Technical Memorandum

Date: June 11th, 2010
To: Brian Beyak, P.Eng, Manitoba Hydro
From: Jamie Ellis, P.Eng, AECOM
Project Number: 0217-200-07 (3) [Hydro Ref: 243 981 0100]
Subject: **Keeyask Infrastructure Project – North Access Road Start Up Camp
Design for Wastewater Disposal
Additional Information at June 11th, 2010**

Figure 1

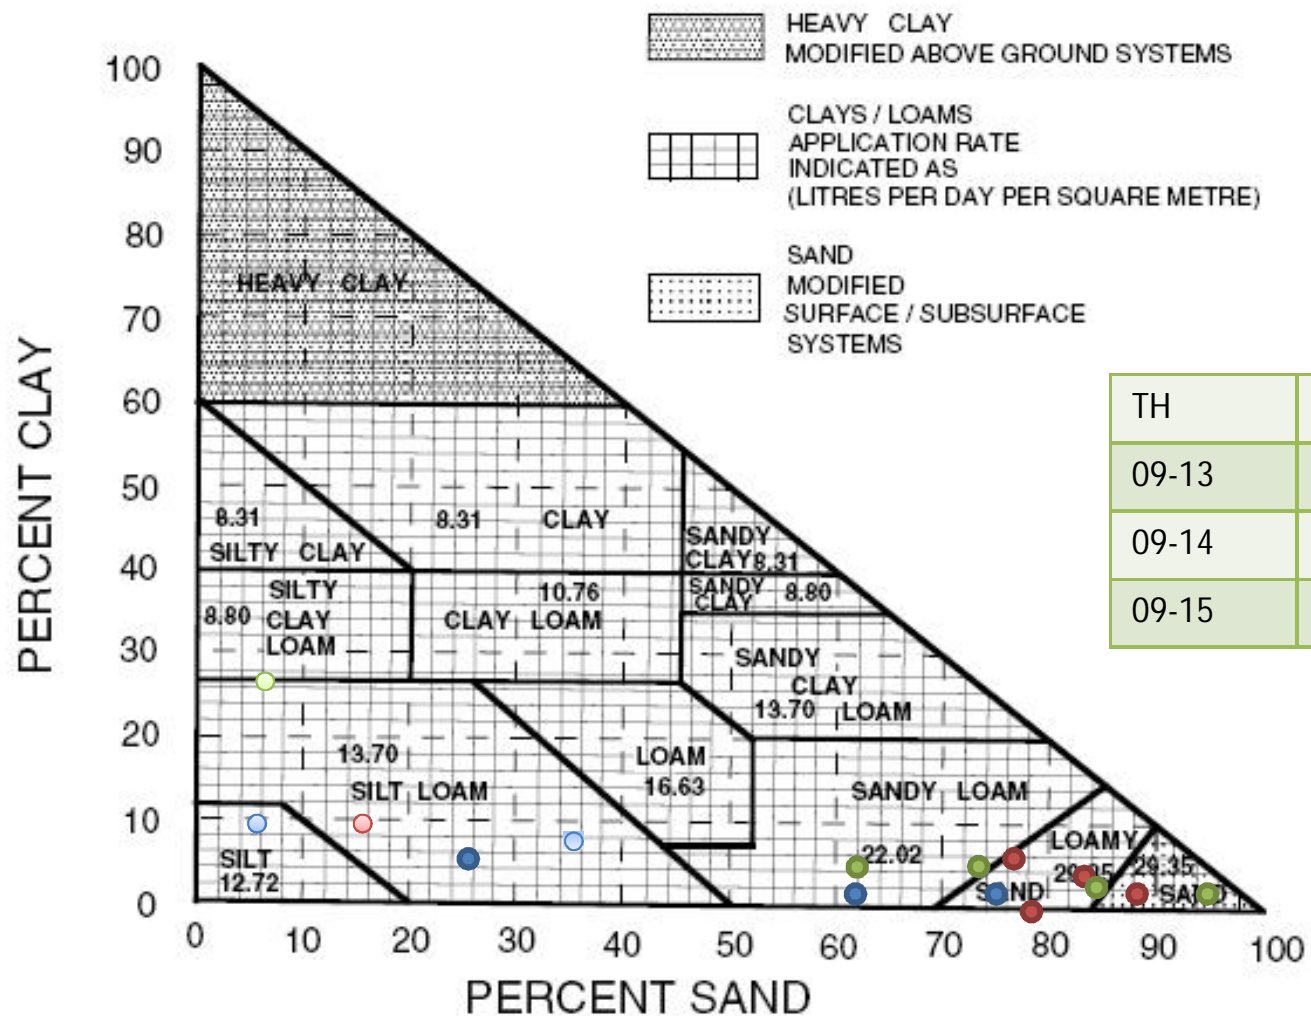
The majority of the soil samples tested for gradation correspond to a silt loam to a loamy sand given the low percentage of clay (i.e. less than 10 percent) and the range of silt and sand percentages. As can be seen from the table in Enclosure 2, whilst some samples did contain greater than 85% sand content, these are at least 1m below the base of the field, and TH09-13 is some 75m away from the west end of the field. Results are summarized on the Soil Texture Classification Triangle contained within the Supplementary Information as shown in **Figure 1 (attached)**. As shown, application rates range from 12.72 to 29.35 litres/m²/day. Therefore, the wastewater application rate assumed in the concept design (12.72 litres/m²/day) was revised to 18 litres/m²/day. Whilst this is not a value within the Soil Texture Classification Triangle, it is considered to be more appropriate and representative of the existing soil conditions. Again, these changes allowed for a reduction in earthworks required for the drain field.

Based on the above, the following equation was used to size the field which gives a field area requirement of 5,000 m².

DRAWN CHECK SCALE AS NOTED DATE	MANITOBA HYDRO KEEYASK GENERATING STATION NORTH ACCESS ROAD STARTUP CAMP DRAIN FIELD - DETAILED SITE PLAN				
	00000-D-00000				
	1004 00				
	SHT. REV.

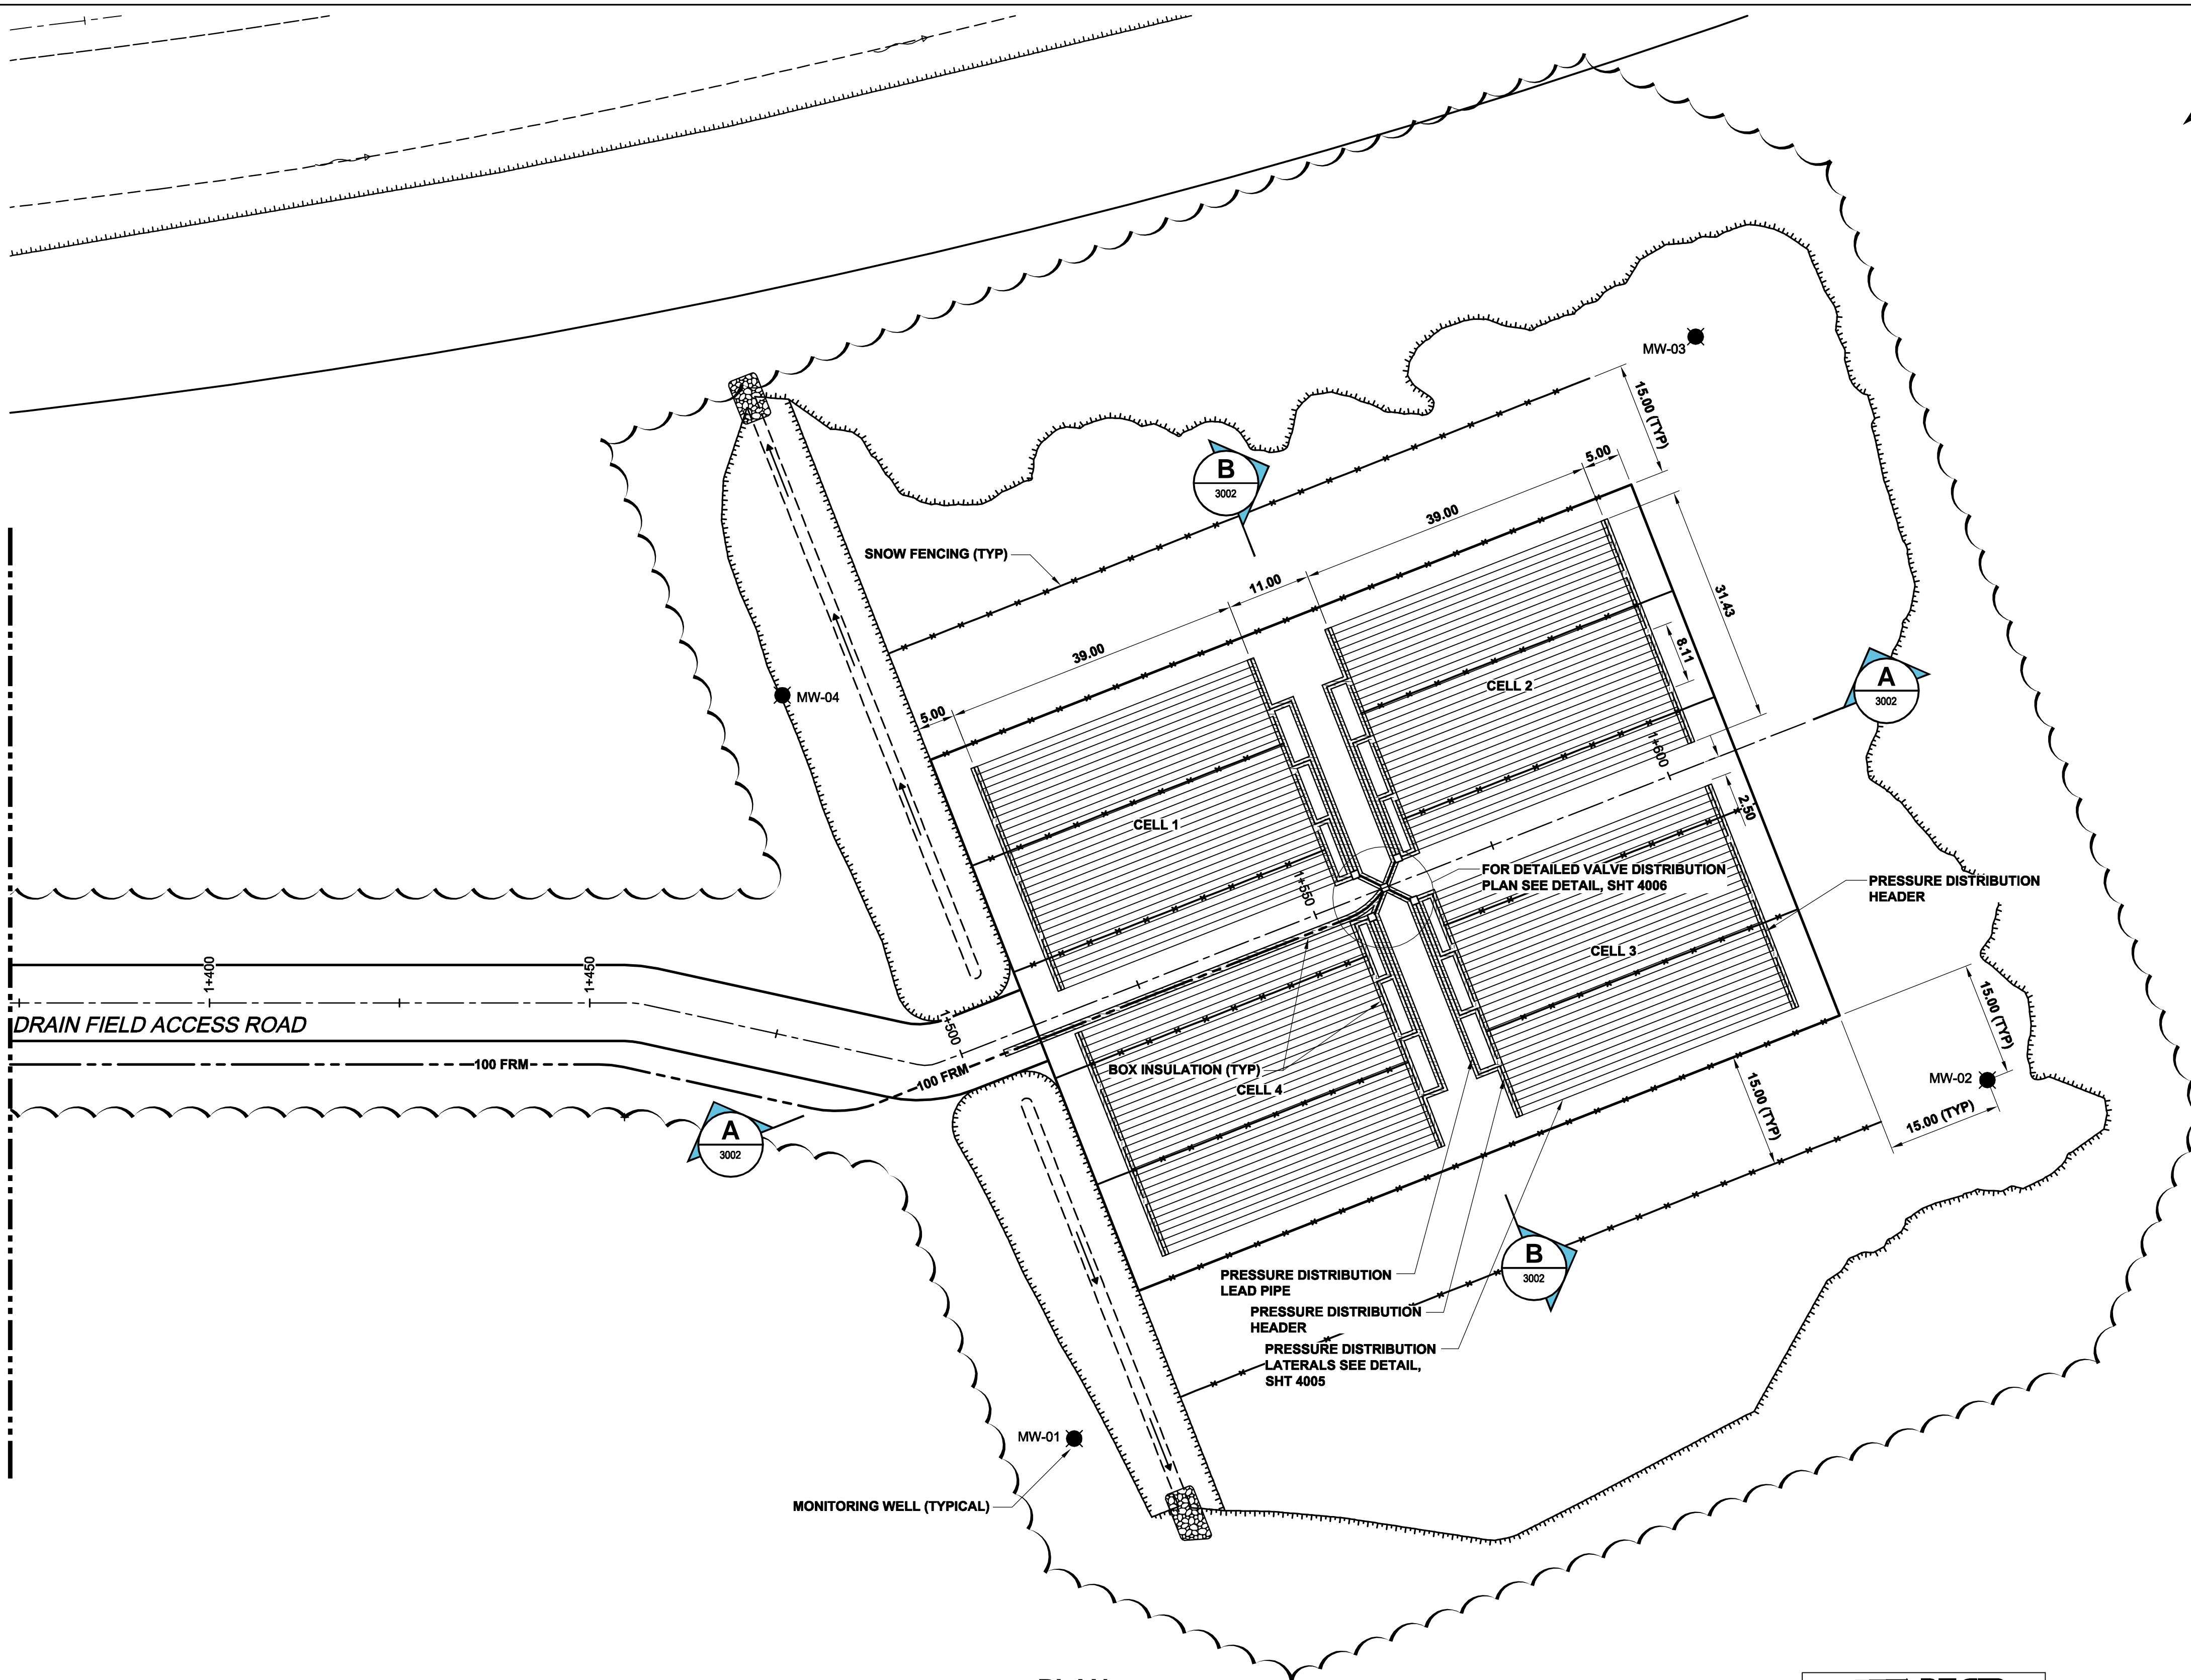
Therefore, sizing calculations were re-examined and it was found that a total area field utilizing effluent chambers now created the smallest foot print, rather than a trench field. This combined with a small change to the location of the field has allowed for a reduction in earthworks quantities.

It should be noted however, that more chambers will be required. It is proposed that the chambers are laid level in the east to west direction. From discussions with Rob Boswick, it is also understood that only the two types of chamber approved for use in Manitoba would be considered acceptable (Infiltrator and ADS brands).

This area has been provided over 4 cells, each with 4 zones measuring 8.1m by 39.0m, giving a total field area of approximately 5060 m².
